# ADDENDUM NO. 2

**July 25, 2022**

**LIBERTY AND WESTCHESTER INTERMEDIATE SCHOOLS -  
ATHLETIC SITE PROJECTS  
Chesterton, IN 46304**

## ADDENDUM TWO

GIBRALTAR DESIGN  
SHEET  
**G-101**

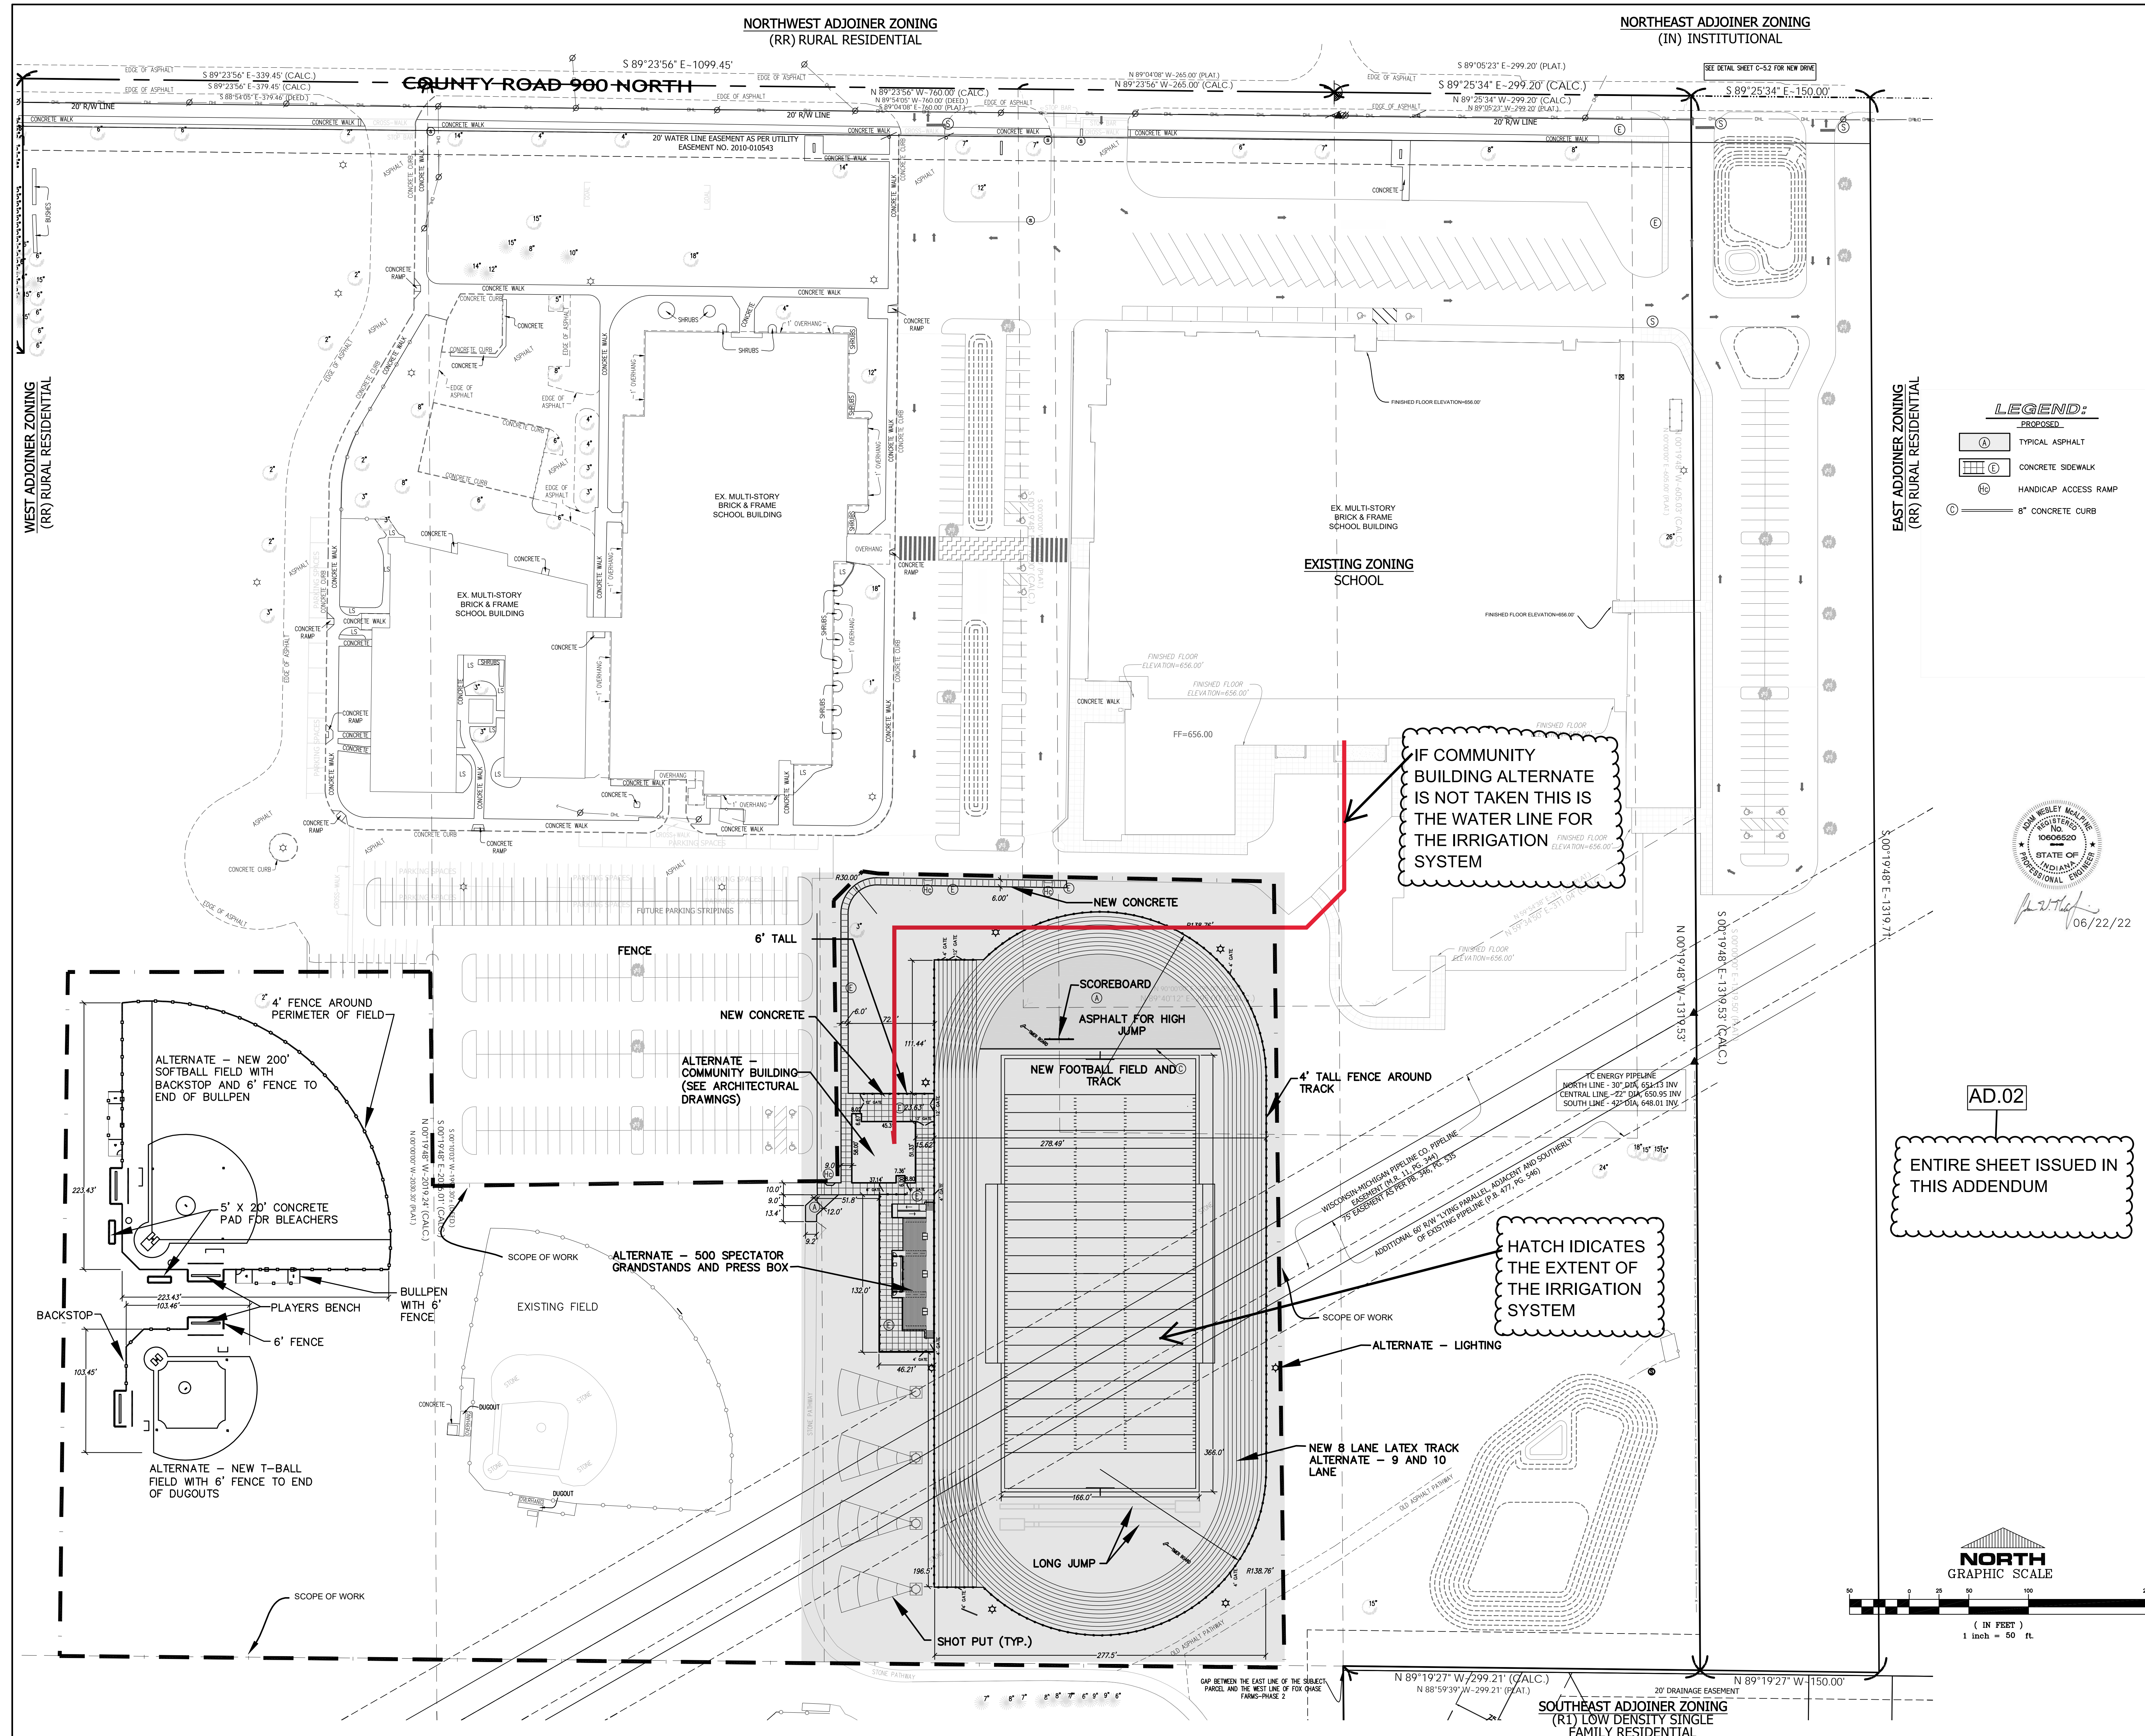
- A. Refer to revised, full-size drawing included in this Addendum, for the following revisions:
  - 1. Add Sheets C-2.0A, C-2.1A, and E-005 to the Sheet Index

© GIBALTAR DESIGN  
SHEET  
C-2.1A

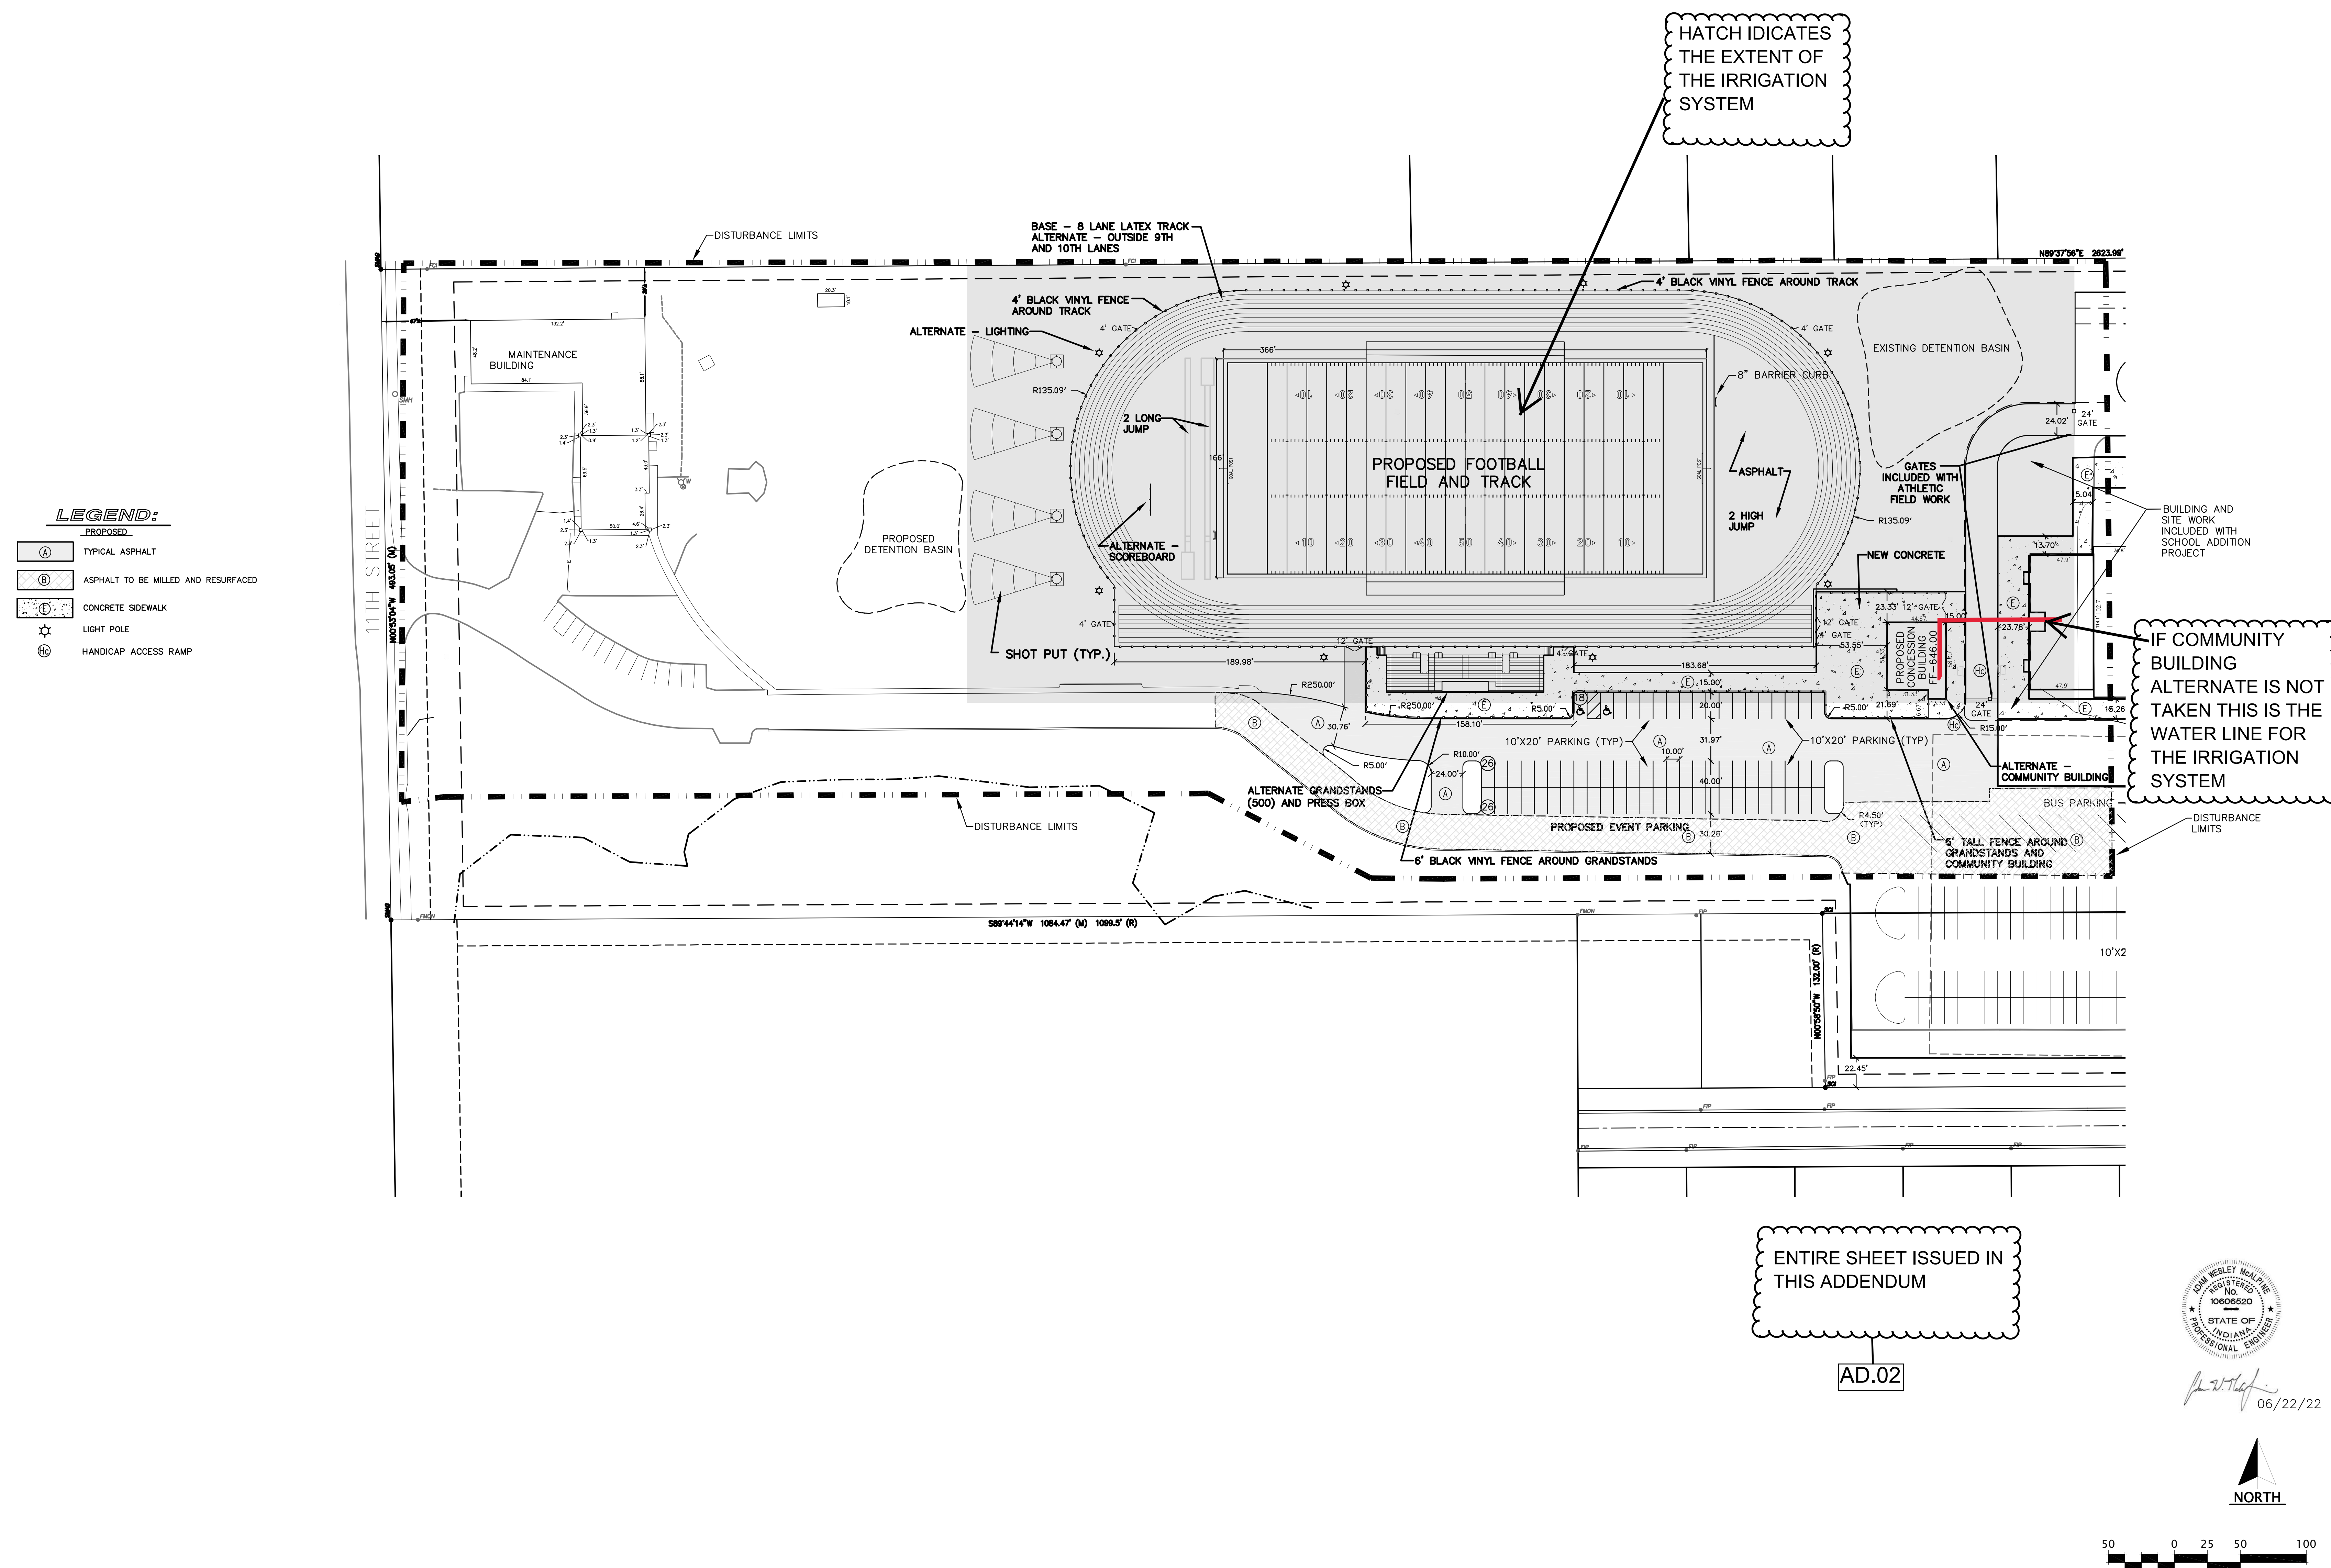
- A. Add sheet C-2.0A in this Addendum for notes on Irrigation.
  - 1. Contractor is to provide a complete and operational irrigation system for the natural turf field and miscellaneous grass areas indicated on the site plan included with this addendum. In Custodial Room A-106, Contractor is to locate the water connection, pump sized as required for size of irrigation system, Irrigation Control Panel/Module, and utilize power connection to the closest electrical panel – install all wiring per Electrical Specifications. Contractor is to install the water connection underground from the Custodial Room to the location of the Concession Building Mechanical Room, if that Alternate is not accepted, then the contractor is to utilize an inground control box to extend the system to the required locations. Contractor is to provide a fully designed system by an Irrigation company that has been operational for a minimum of five years and installed systems of comparable size as indicated for this project.

© GIBRALTAR DESIGN SHEET  
**WIS ES102**

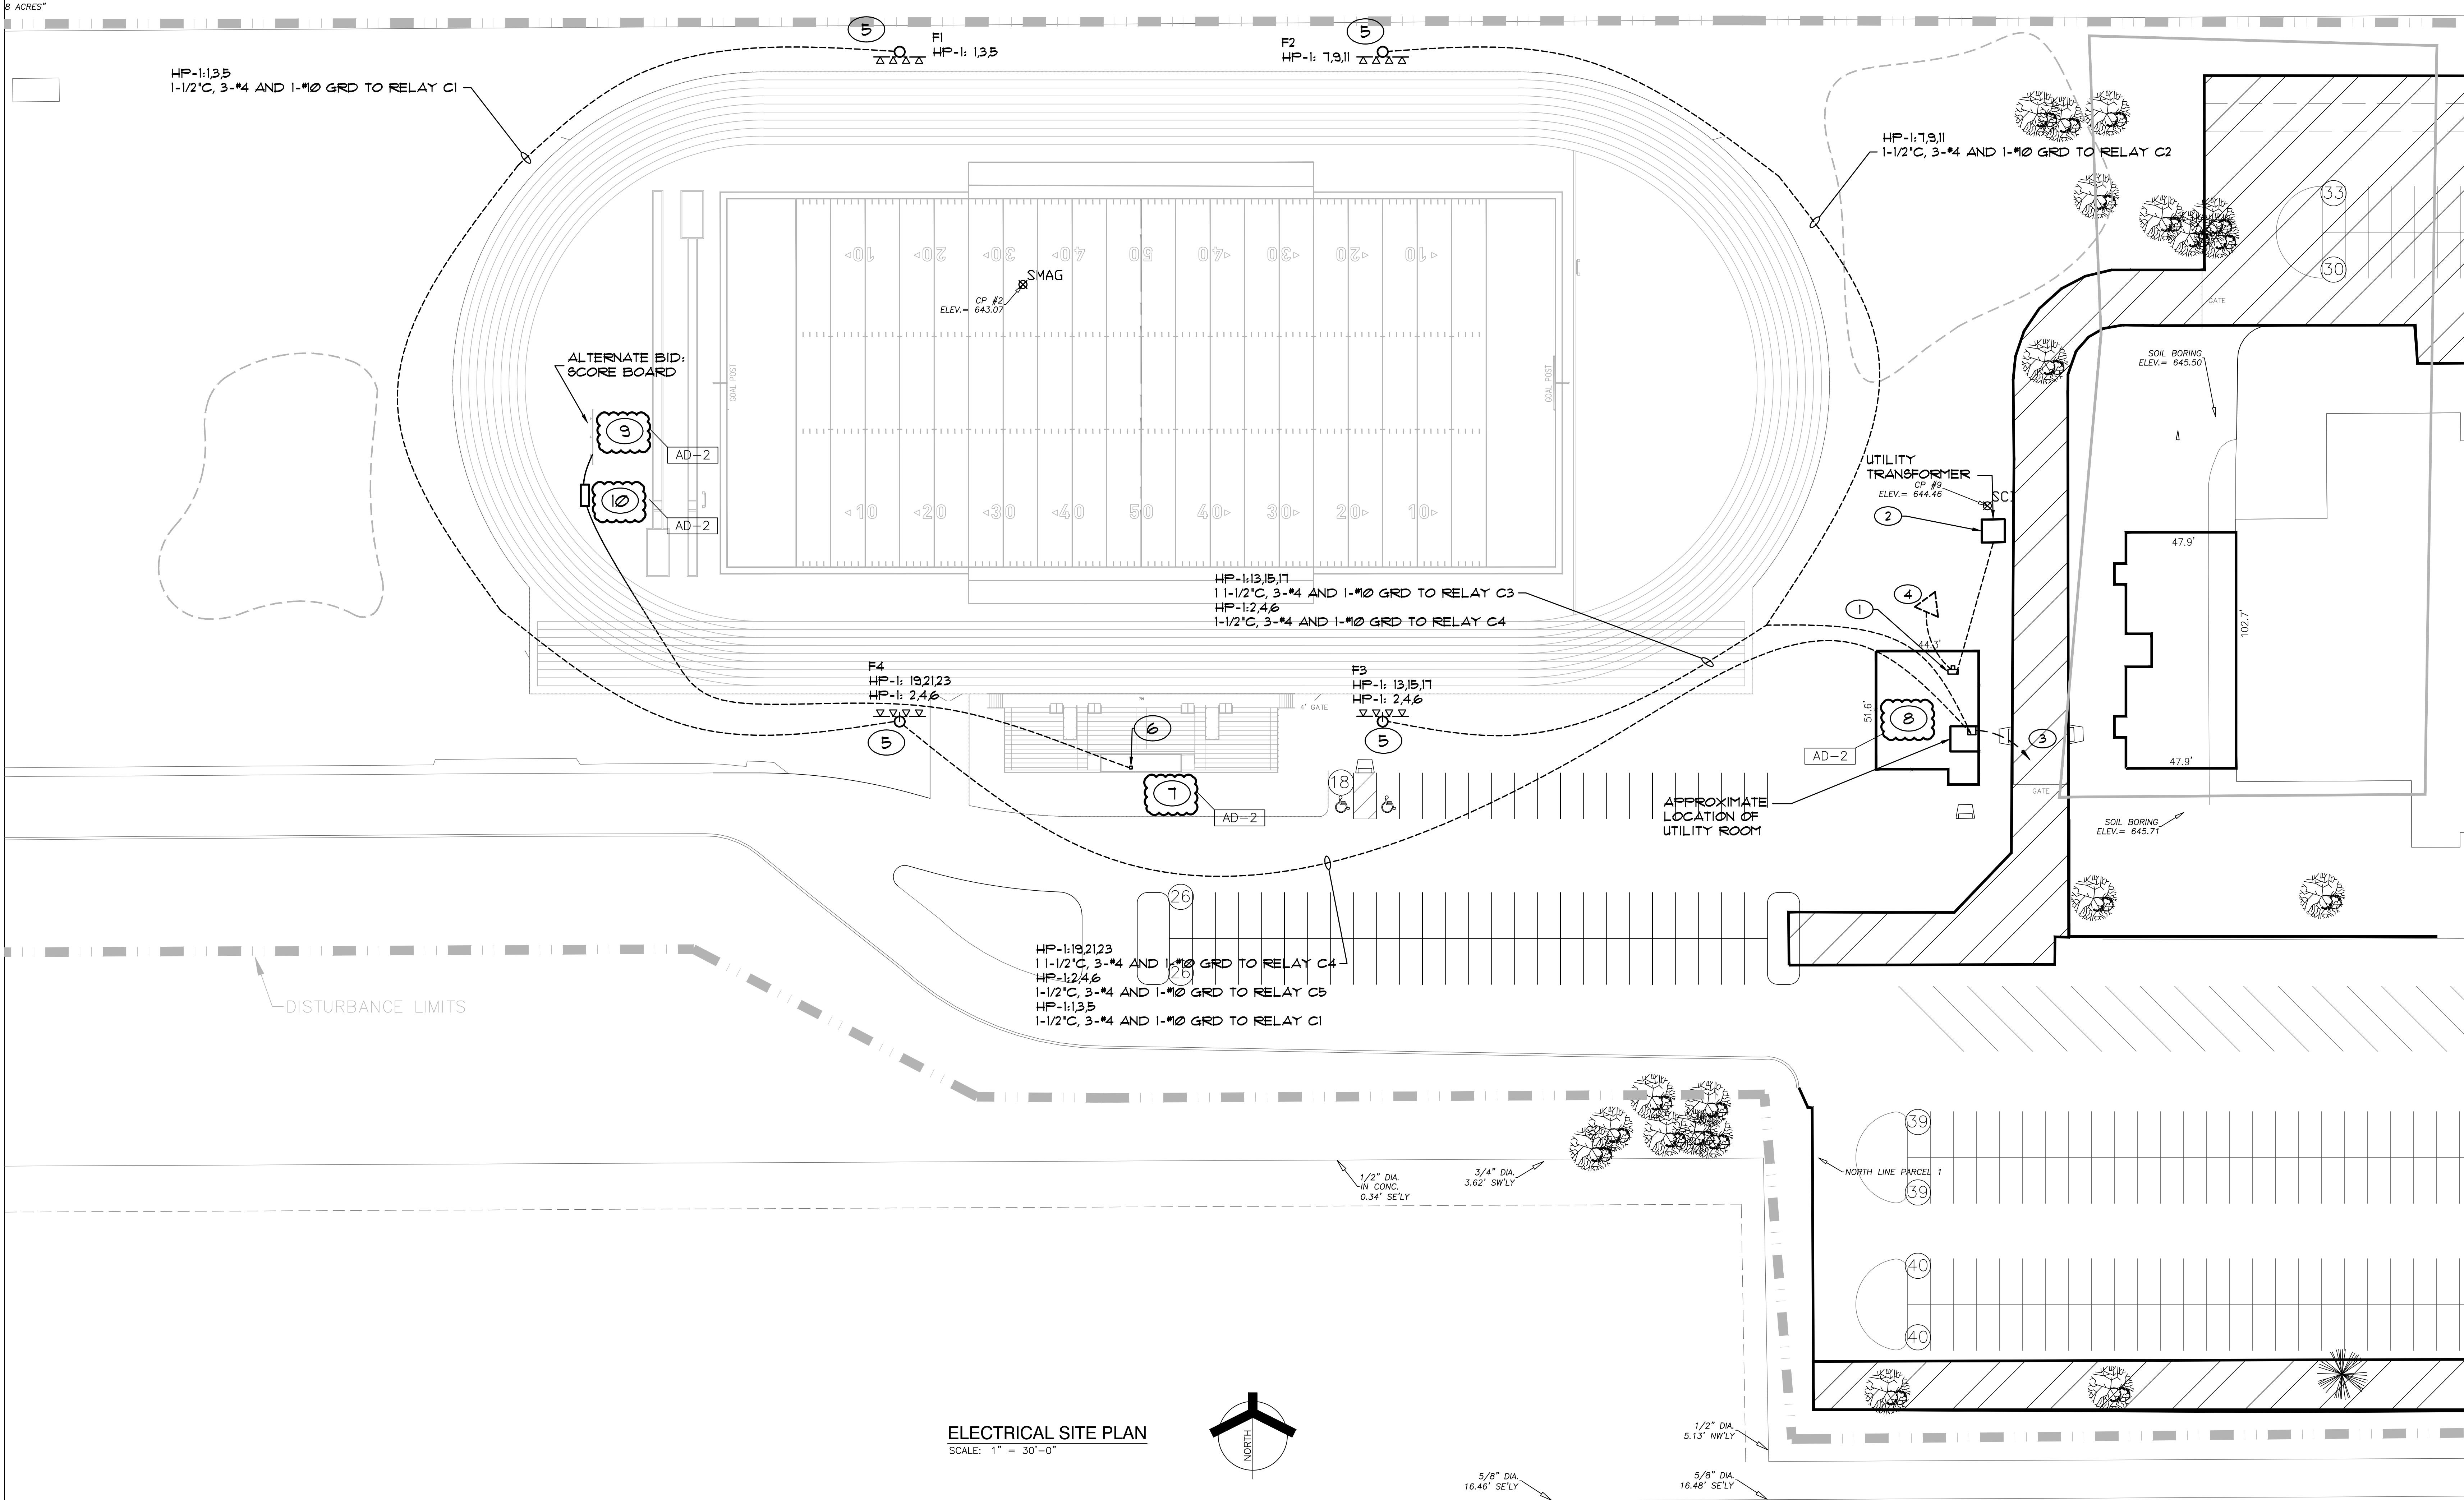
- A. Refer to revised, full-size drawing included in this Addendum, for the following revisions:
  - 1. Clarify plan notes identifying Alternate Bids.
  - 2. Add low voltage pedestal per low voltage drawings.
